## DESIGN REVIEW/CERTIFICATE OF APPROPRIATENESS APPLICATION

PROPERTY INFORMATION			
Project/Property Address: Hamilton Road		Project Name/Business Name: Orthopedic One Gahanna / Orthopedic One	
Parcel #: 025-013767-00	Zoning: (see <a href="#">Map</a> ) <b>SCPD</b>	Acreage: 9.13 ac

Attention: Kelly Wicker  
Planning and Zoning Coordinator  
RE: Response Letter #1  
Project Hamilton Rd Ortho One Design Review/C of A

**2 DECID. TREE PLANTING DETAIL**  
NTS

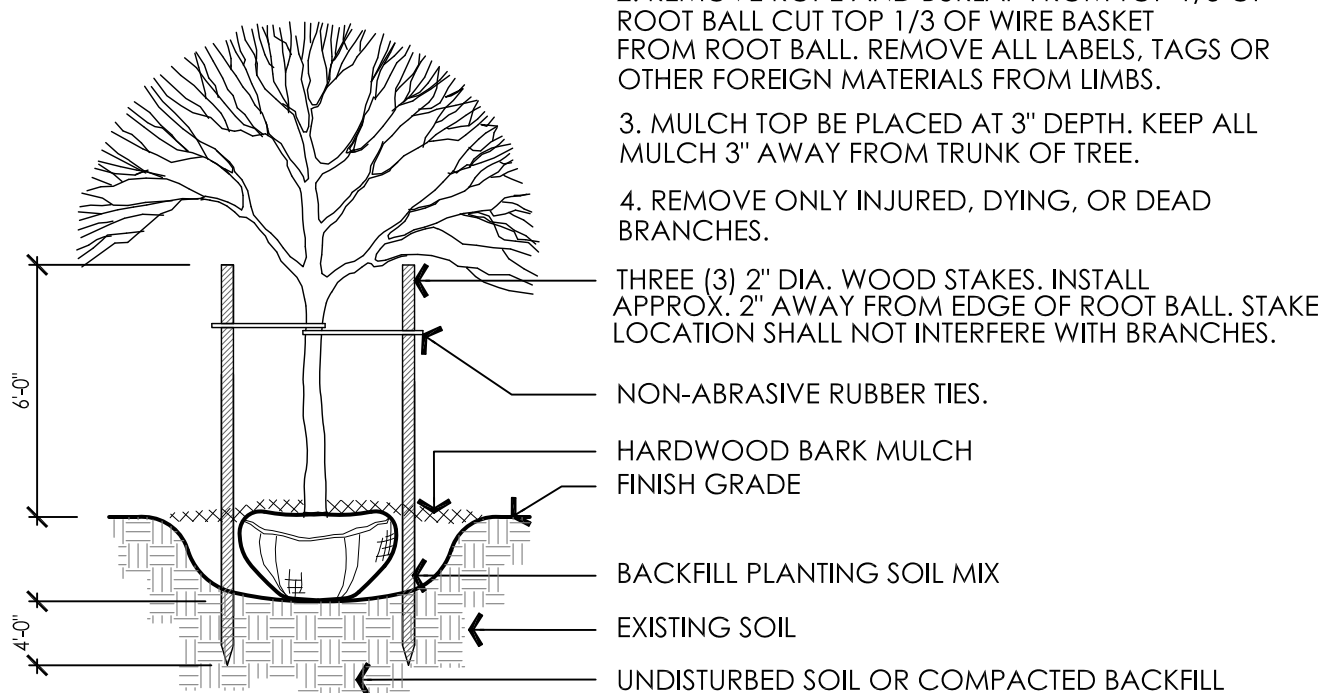
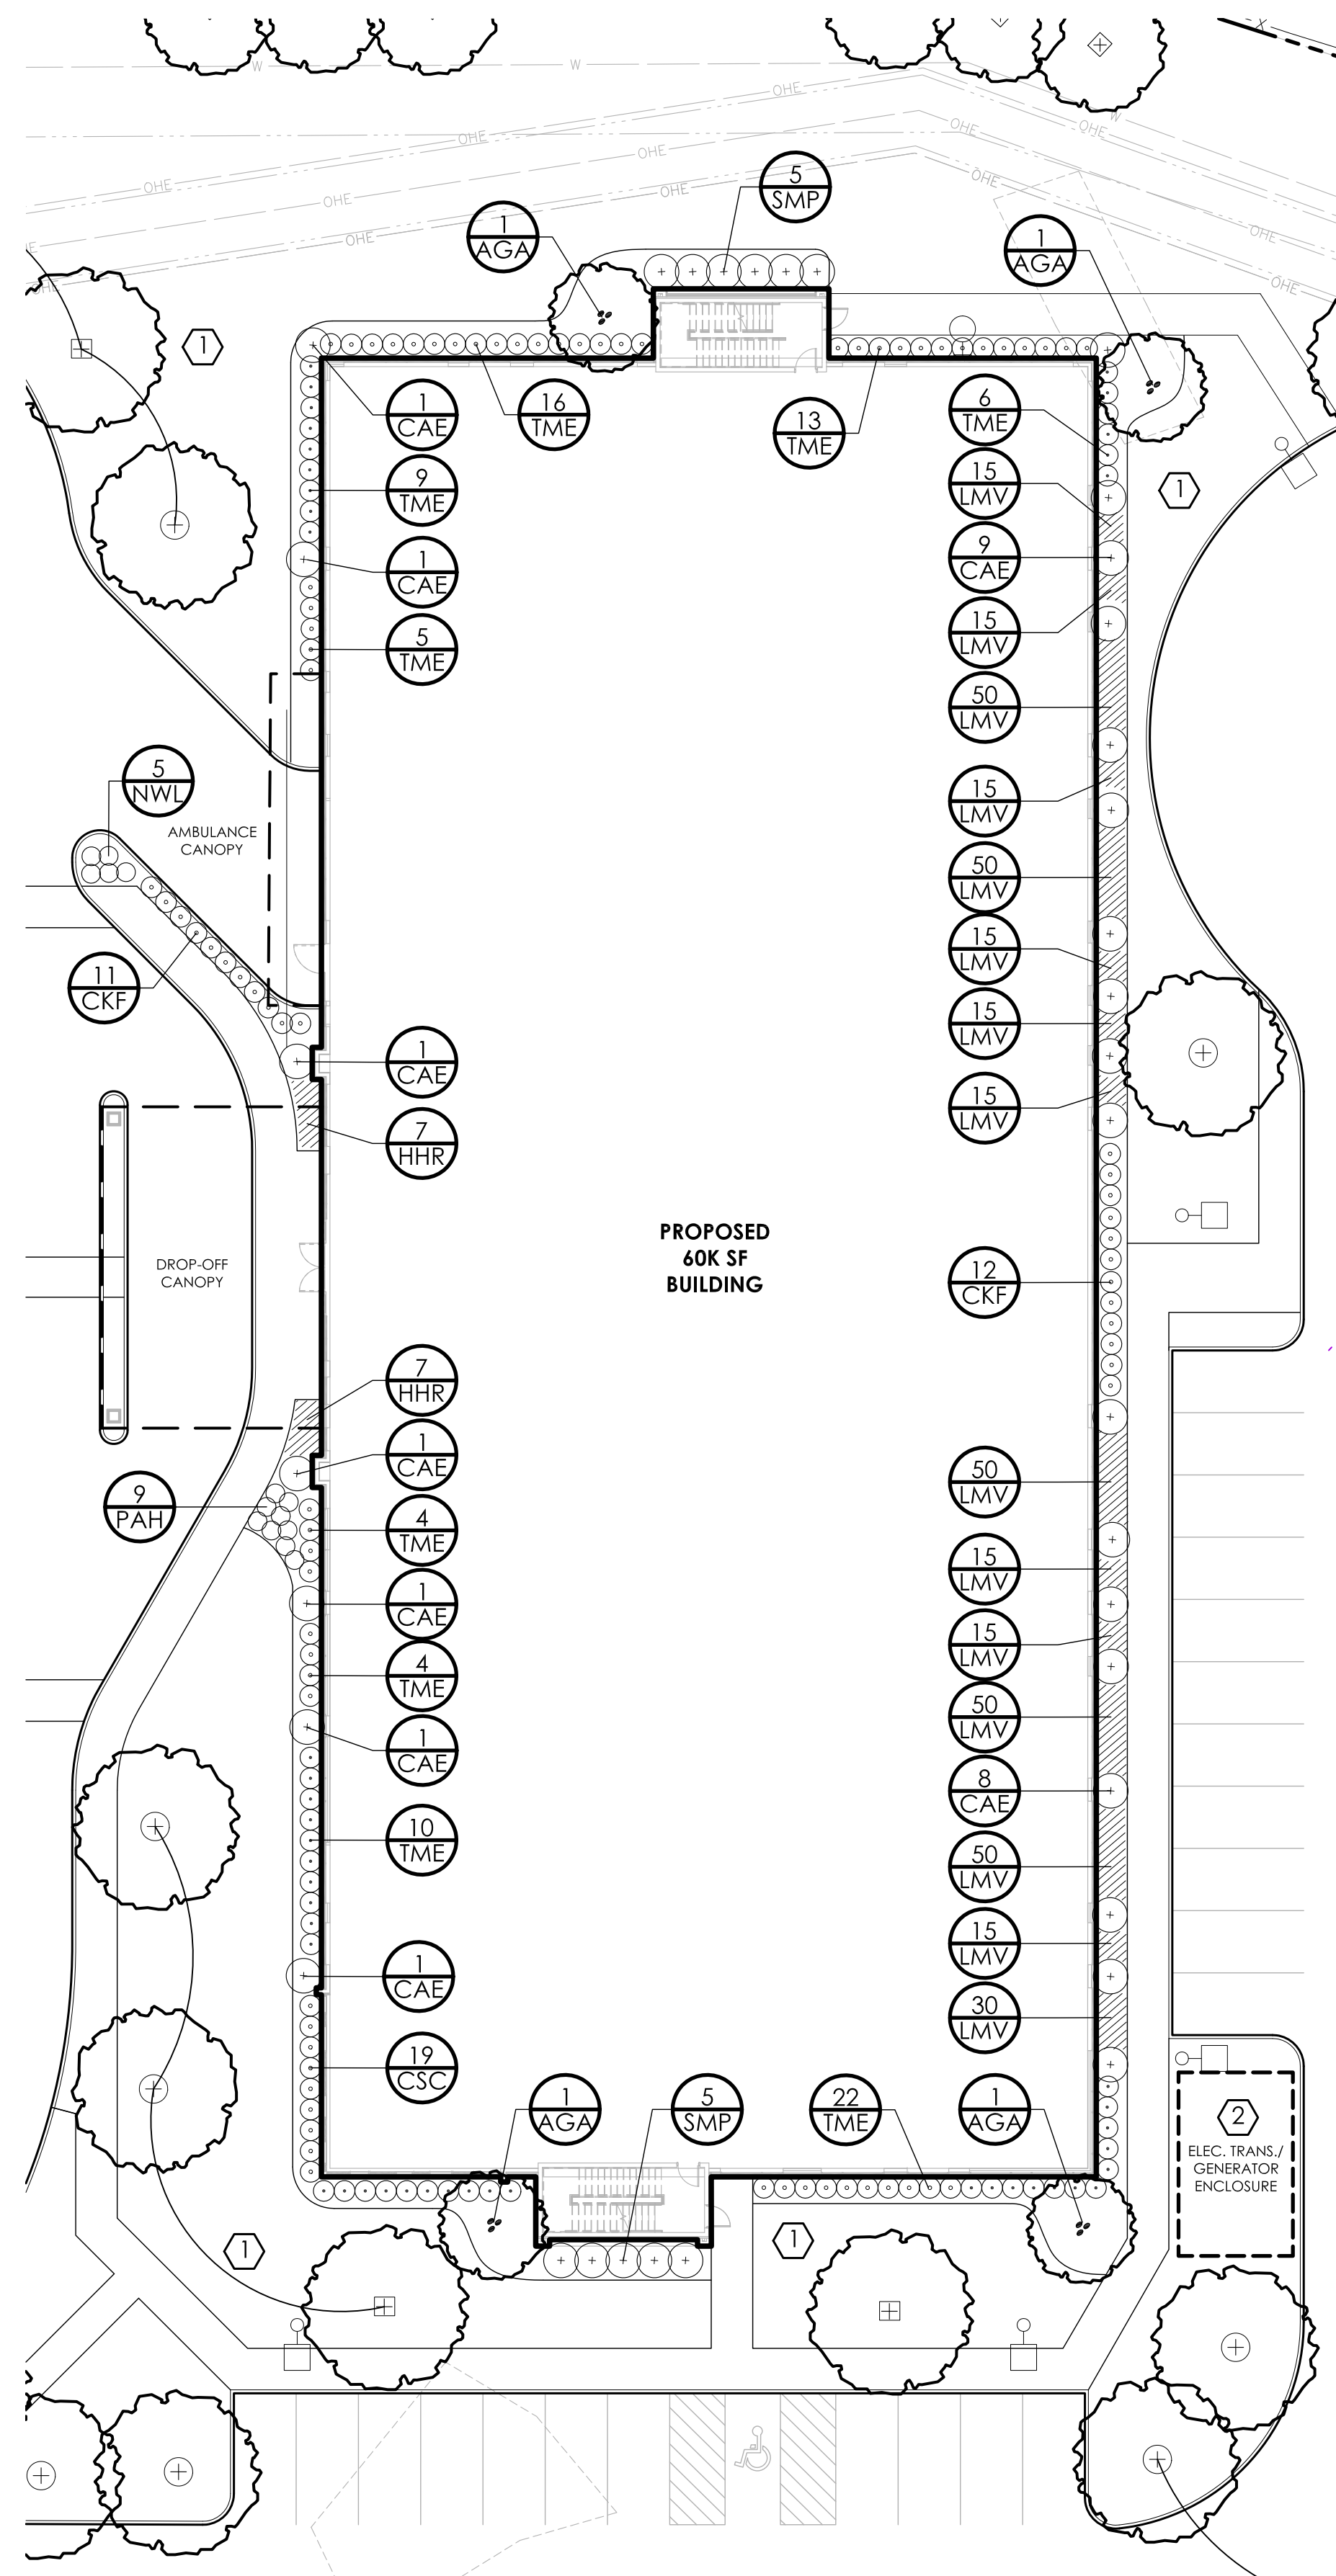
6. Tree planting detail looks appropriate for the most part. If there are broken or damaged branches at planting, these branches should be pruned. Staking should be considered for the first year to prevent trees from leaning.

**Response: Notes addressing removal of broken branches are included in written specifications to the contractor but can be added to the detail. Staking will be considered.**

ILLUSTRATIVE SITE PLAN

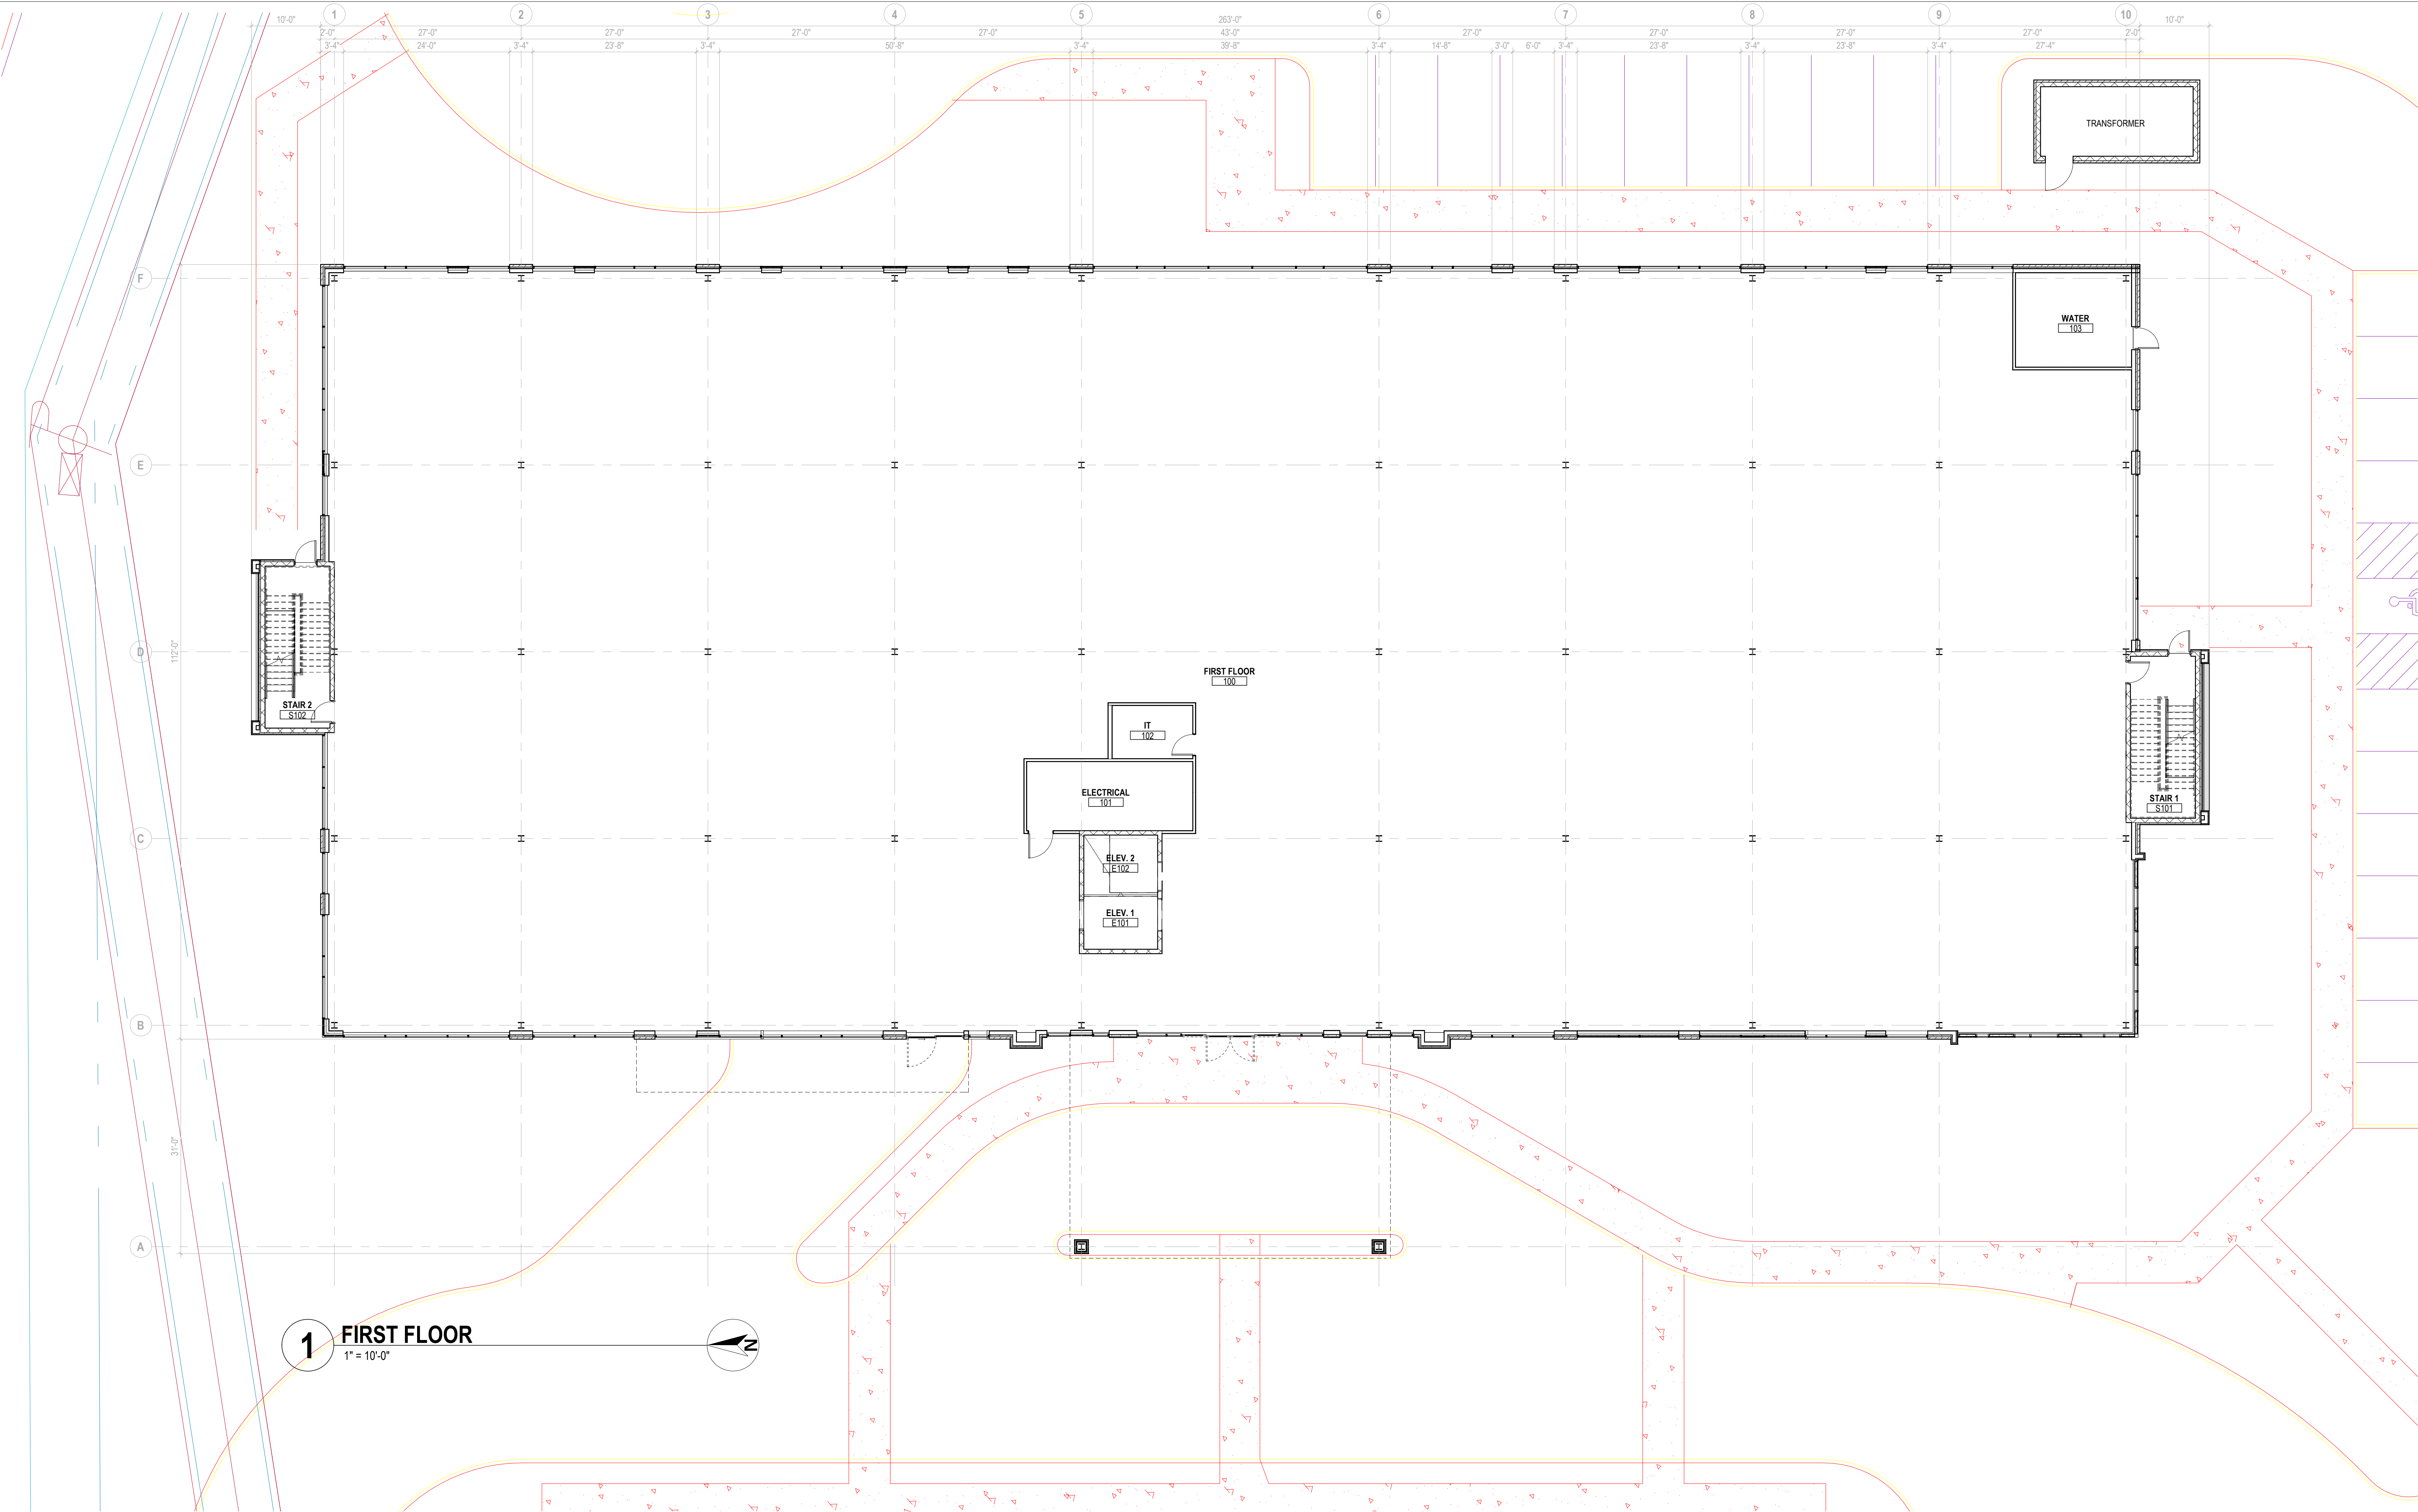
5. Species selection looks appropriate for the most part. I advise against the use of crabapples since they are prone to many diseases, but they are not prohibited. A substitution for more serviceberries could be considered.

**Response: Spring Snow Crabapples are a fruitless variety that have better disease resistance than many other Malus species. This fruitless tree is specified to avoid attracting birds known to be of concern for the adjacent airport. Serviceberries are used in small quantities around the building.**
